UNITED STATES PATENT AND TRADEMARK OFFICE

APPLICATION NO.	FILING DATE	FIRST NAMED INVENTOR	ATTORNEY DOCKET NO.	CONFIRMATION NO.
10/678,028	09/29/2003	Sameer P. Pendharker	TI-33654	9934

Office Action Summary

DETAILED ACTION

FIG. 1

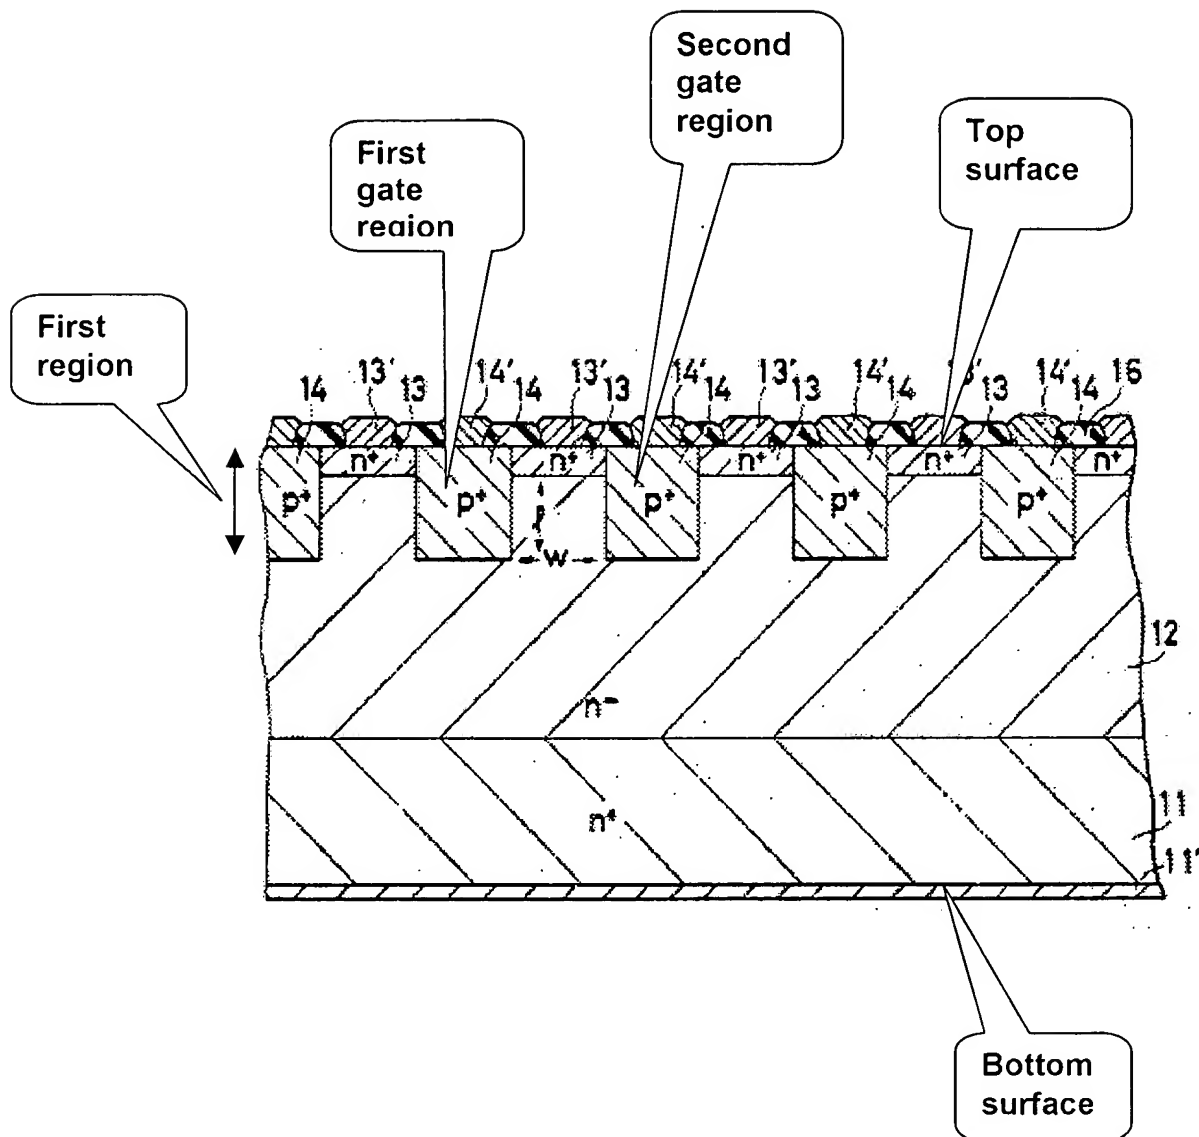
Regarding claim 2, Nishizawa (Fig. 1) discloses an integrated-circuit device, comprising:

a substrate 11 (column 2, line 66), having a top surface and a bottom surface;
a first region near the top surface (corresponding to the top portion of layer 12, see Fig. 1 labeled by the examiner below);

a first and second gate regions 14 in the first region (column 3, line 2), each having a top surface, a bottom surface and a side surface;

the side surfaces of the first and second gate regions 14 being substantially parallel to each other and substantially perpendicular to the top surface of the substrate 11 (see Fig. 1 Labeled by the examiner below);

the top surface of the first gate region 14 being electrically communicable to a gate terminal 14' (column 3, lines 2-5);

a channel region (W) in the first region, between the first and the second gate regions 14 (column 3, lines 10-15) having side surfaces adjacent to the side surfaces of the gate regions 14, a top surface, and a bottom surface; and

the top surface of the channel region (W) electrically communicable to a source terminal 13', the bottom surface of the channel region (W) electrically communicable to a drain terminal 11'.

Regarding claim 3, Nishizawa (Fig. 1) discloses that the channel region (W) passes an electric current from the source region 13 to the drain region 11 in a direction substantially perpendicular to the top surface of the substrate 11 upon a biasing voltage being applied between the source terminal 13' and the drain terminal 11' (column 5, lines 64-68 through column 6, lines 1-7), and the magnitude of the current in the channel region is controllable with a biasing voltage at the gate terminal 14' (column 3, lines 48-56).

Regarding claim 9, Nishizawa (Fig. 1) discloses that the substrate 11 is a bonded wafer having a bonded layer 12 formed thereon.

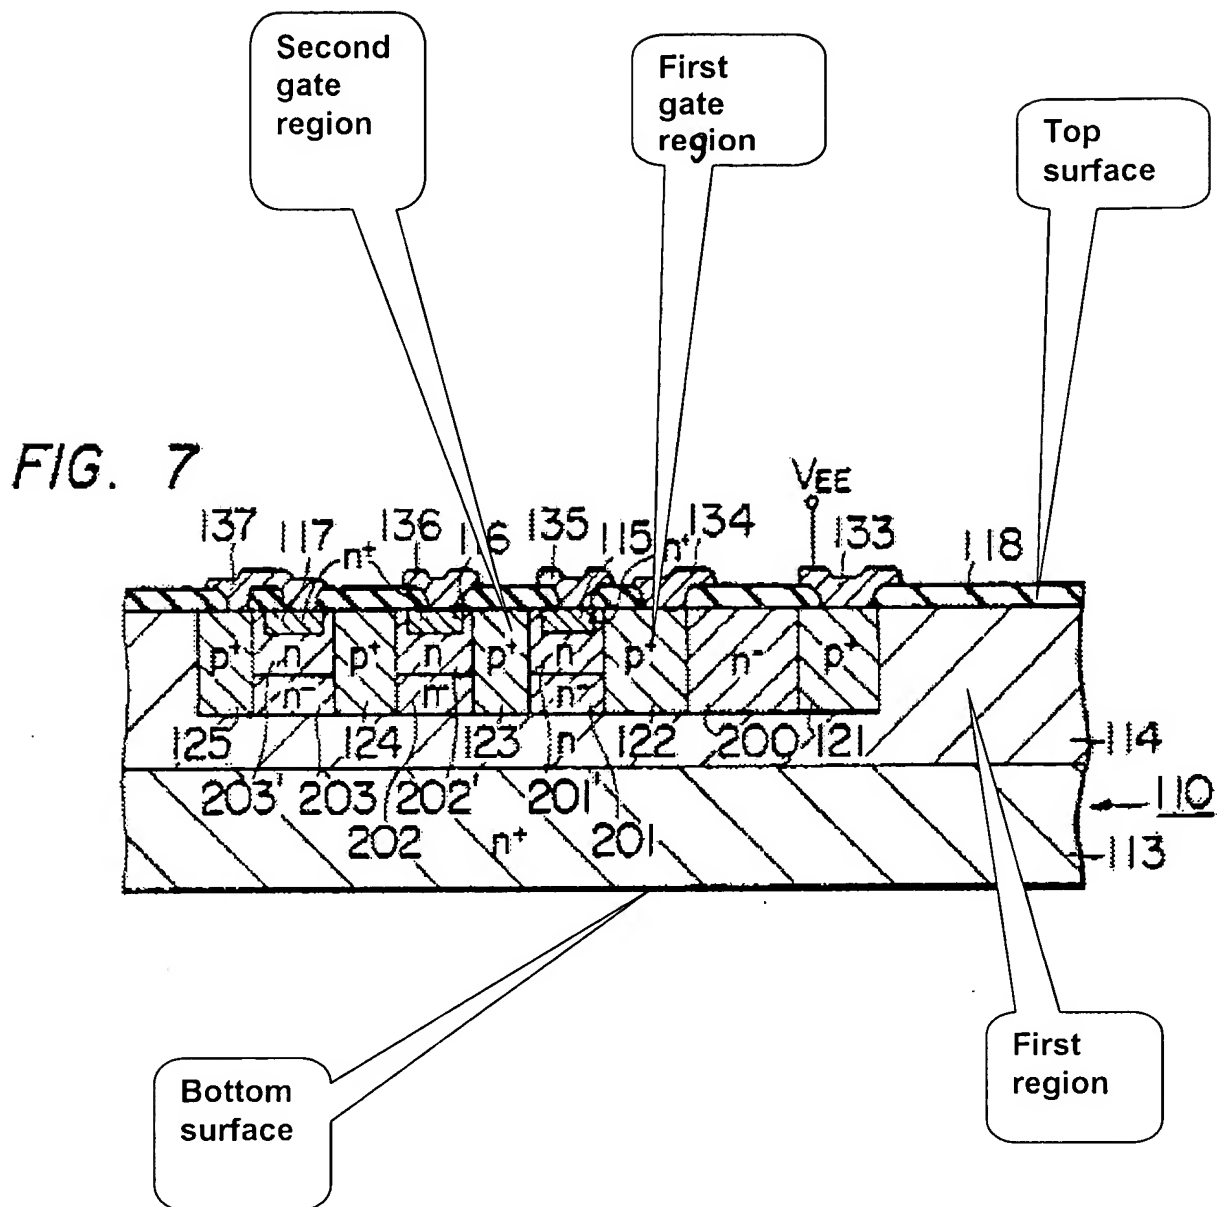
Regarding claim 2, Nishizawa'618 (Fig. 7) discloses an integrated-circuit device, comprising:

a substrate 113 (column 6, lines 20-22), having a top surface and a bottom surface;

a first region 114 near the top surface;

a first and second gate regions (122,123) in the first region 114 (column 7, lines 9-10), each having a top surface, a bottom surface and a side surface;

the side surfaces of the first and second gate regions (122,123) being substantially parallel to each other and substantially perpendicular to the top surface of the substrate 113 (see Fig. 7 Labeled by the examiner below);

the top surface of the first gate region 122 being electrically communicable to a gate terminal 134;

a channel region 201 in the first region 114 (column 9, lines 22-26), between the first and the second gate regions (122,123) having side surfaces adjacent to the side surfaces of the gate regions (122,123), a top surface, and a bottom surface (column 9, lines 32-34); and the top surface of the channel region 201 electrically communicable to a drain terminal 135 of a drain region 115 (column 7, line 10), the bottom surface of the channel region 201 electrically communicable to a source terminal 113 (column 7, lines 13-15).

Regarding claim 3, Nishizawa'618 (Fig. 7) discloses that the channel region 201 passes an electric current from the drain region 115 to the source region 113 in a direction substantially perpendicular to the top surface of the substrate upon a biasing voltage being applied between the source terminal 113 and the drain terminal 115 (column 11, lines 4-8), and the magnitude of the current in the channel region is controllable with a biasing voltage at the gate terminal 122 (column 7, lines 42-49).

Regarding claim 10, Nishizawa'618 discloses that the first gate region 122 has a pill-box shape with a substantially flat top surface and bottom surface and a side surface substantially perpendicular to the top and bottom surfaces (see Fig. 7 above).
